#2013-14 Anderson VW

Project Review for Planning and Zoning Commission

Requests: Variations for landscaping and lighting for an auto dealership.

Location: 5213 Northwest Highway

E4.2
Revision 7

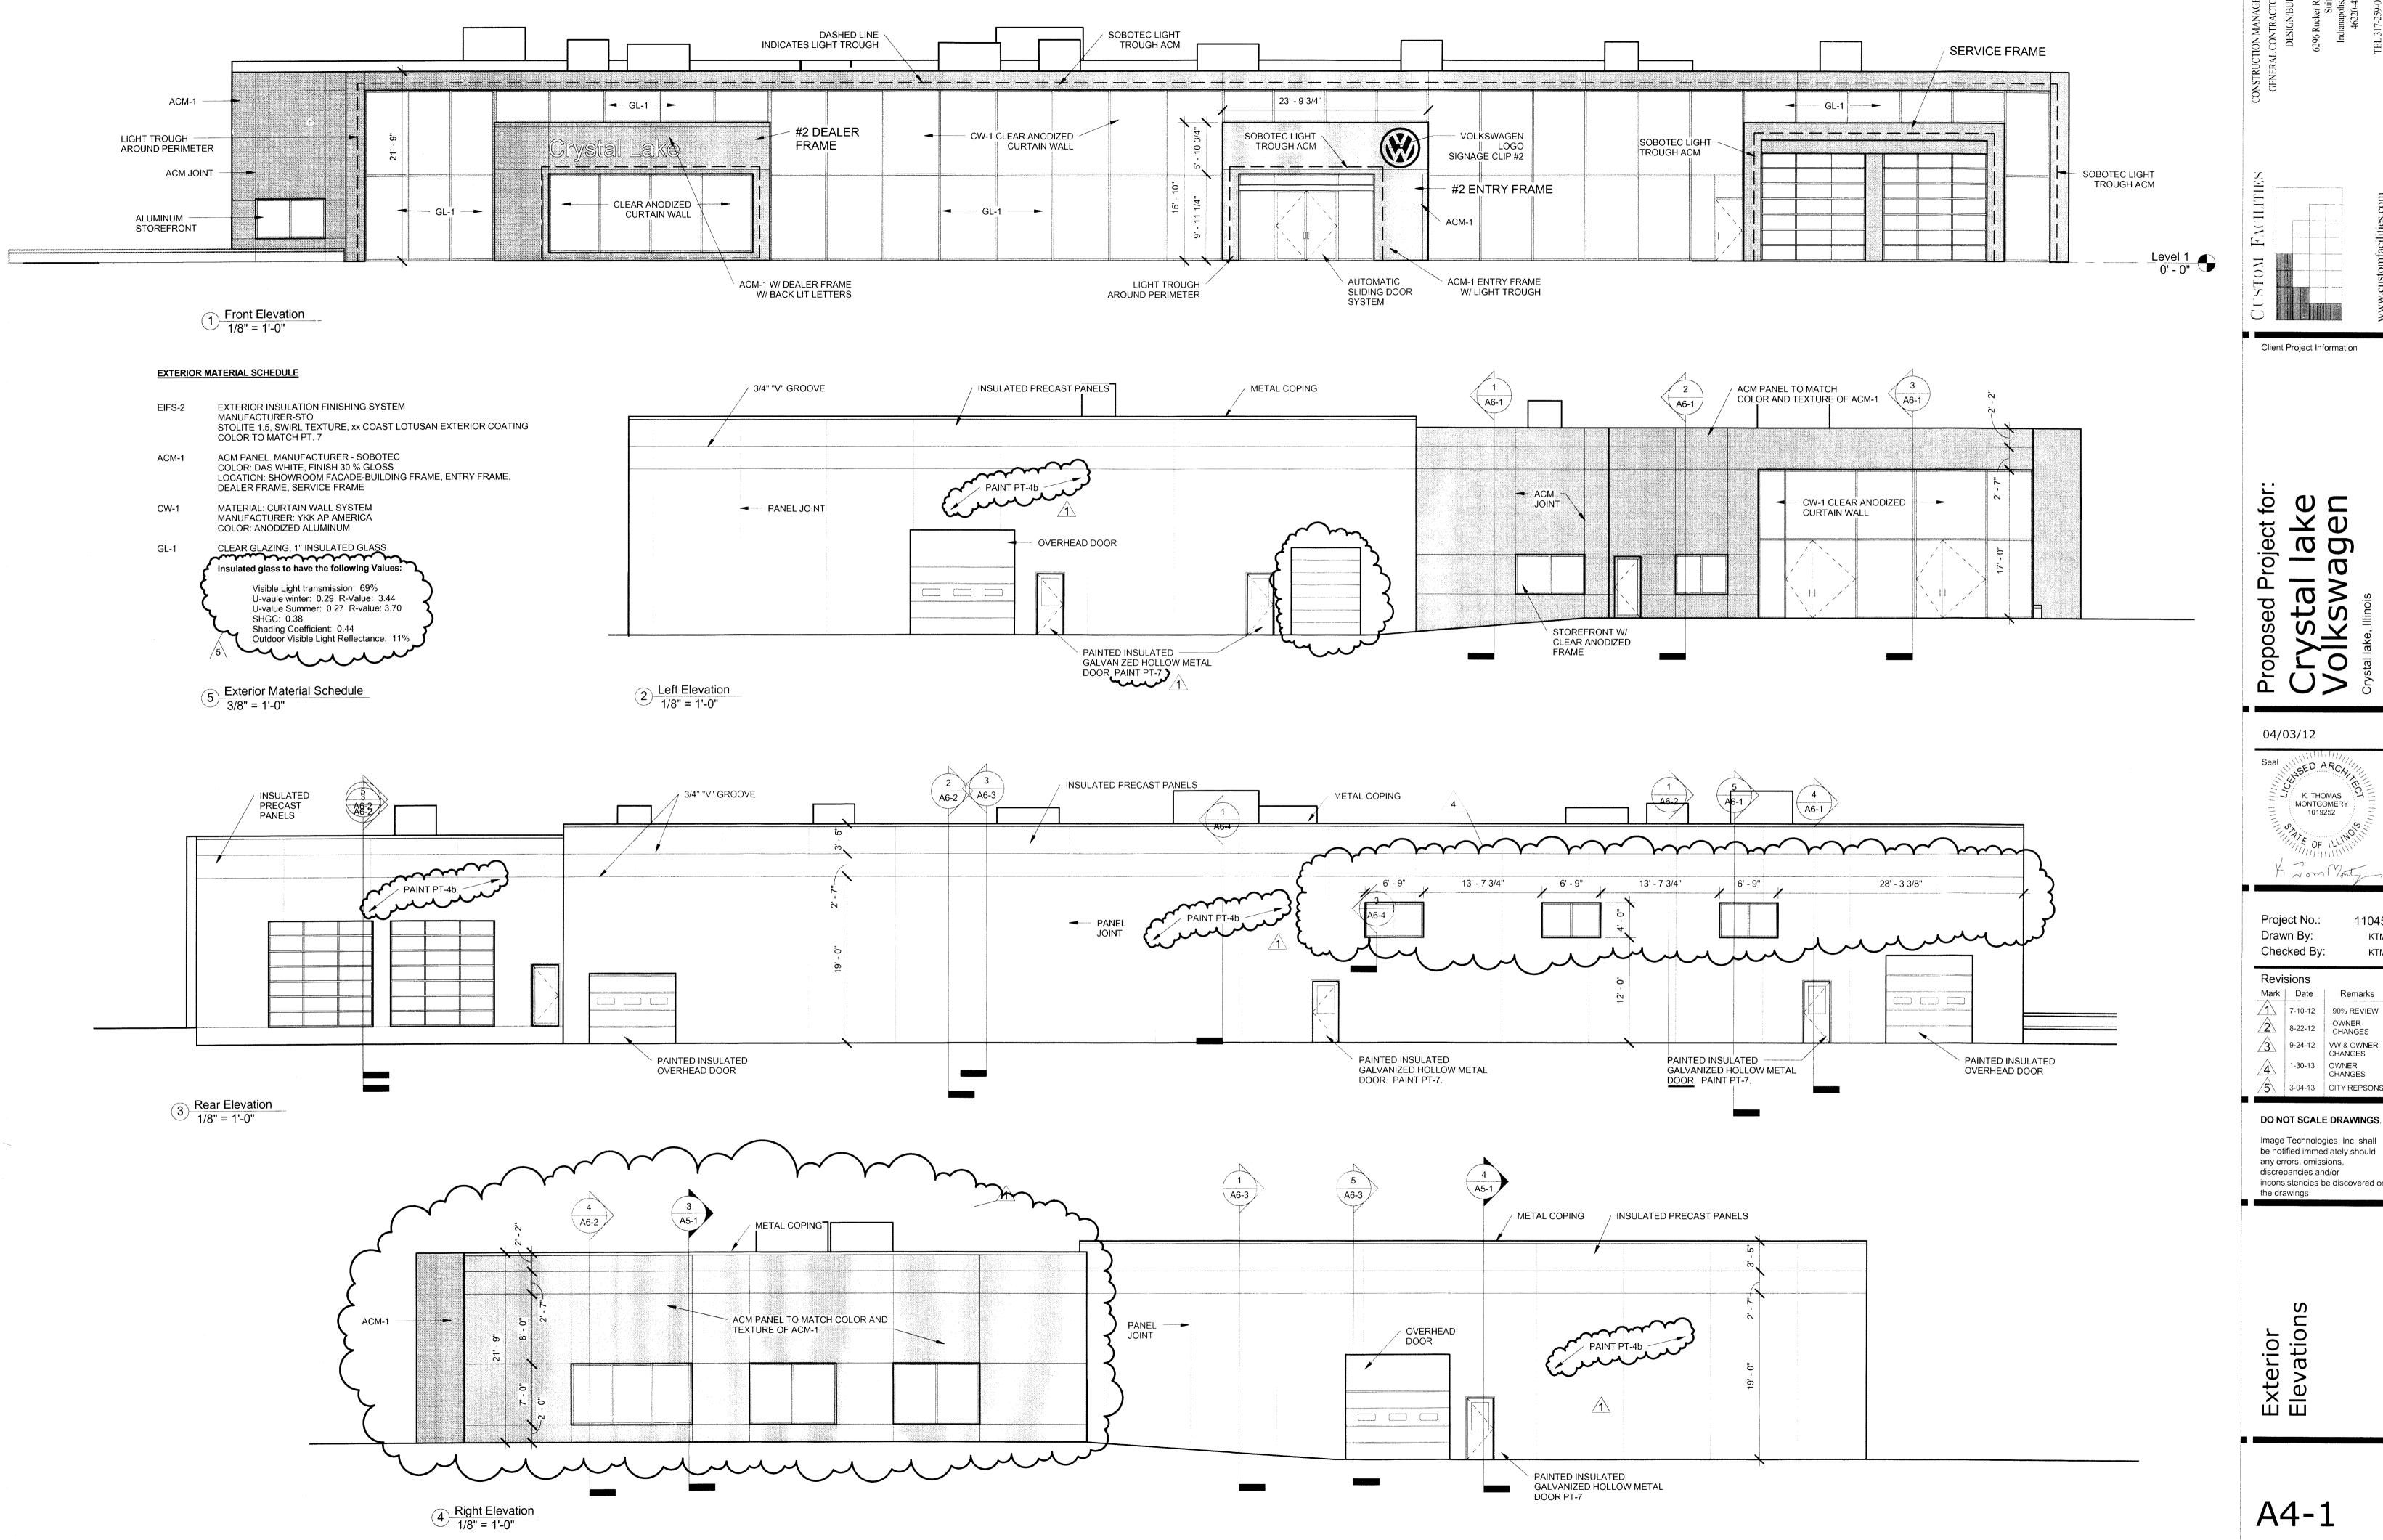
There are two facets to this request: site and building lighting. The site is held to overall illumination levels that have been implemented by the UDO for auto dealerships. The requirement is 20 maximum average footcandles (fc) for front row display and 10 maximum average fc for the remaining display areas. The plan shows up to 52 fc for the front row and 25-35 fc for the other areas. This correlates almost exactly to what Pauly Toyota has on their site.
